Access Compliance Report Public Rights-of-Way (Curb Ramps)

Main Street: BIGELOW_PKWY		Cross Street: HOLT_AVE		Location:	NW
ADA ID: RPRK211011130042	Ramp Type: Type 7 - Directional 2	Initial Pass/Fail: Fail	Overall Compliance: No	Severity Score:	15
Codes/Mitigation Info/Possible Solution			Field Measurements/Component Compliance

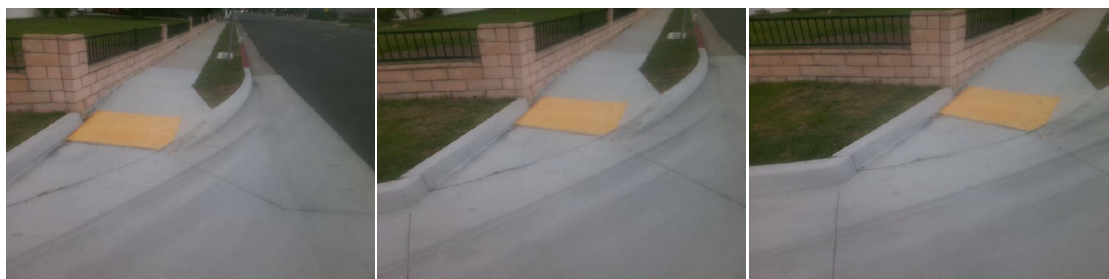
Compliance	Description	Data	Compliance	Description	Data
N/A	Ramp Length (in)	150	N/A	Flare Type LT	
Yes	Ramp Width (in)	60			N/A
No	Ramp Run Slope (%)	11.8	N/A	Flare Slope LT (%)	N/A
Yes	Ramp Cross Slope (%)	1.8	N/A	Flare Traversable LT	N/A
N/A	Grade Break	N/A	N/A	Flare Type RT	
N/A	Grade Break Slope (%)	N/A			N/A
N/A	Grade Break Cross Slope (%)	N/A	N/A	Flare Slope RT (%)	N/A
	Addl Para Ramp Left?	No	N/A	Flare Traversable RT	N/A
	Addl Para Ramp Right?	No	N/A	DWS Provided	N/A
N/A	Landing Present	N/A	N/A	DWS Contrast	N/A
N/A	Landing Length (in)	N/A	N/A	DWS Length (in)	N/A
N/A	Landing Width (in)	N/A	N/A	DWS Full Width	N/A
N/A	Landing Run Slope (%)	N/A		DWS Offset Type	N/A
N/A	Landing Cross Slope (%)	N/A	N/A	DWS Left Offset (in)	N/A
N/A	Landing Movement Obstructed?	N/A	N/A	DWS Right Offset (in)	N/A
	Landing Movement Type	N/A			
N/A	Landing Shared	N/A			
N/A	Marked Crosswalk 1	No	N/A	Clear Space	N/A
	Crossing 1 Direction	S	N/A	Clear Space To Crosswalk (in)	N/A

Remove & Replace Entire Ramp.
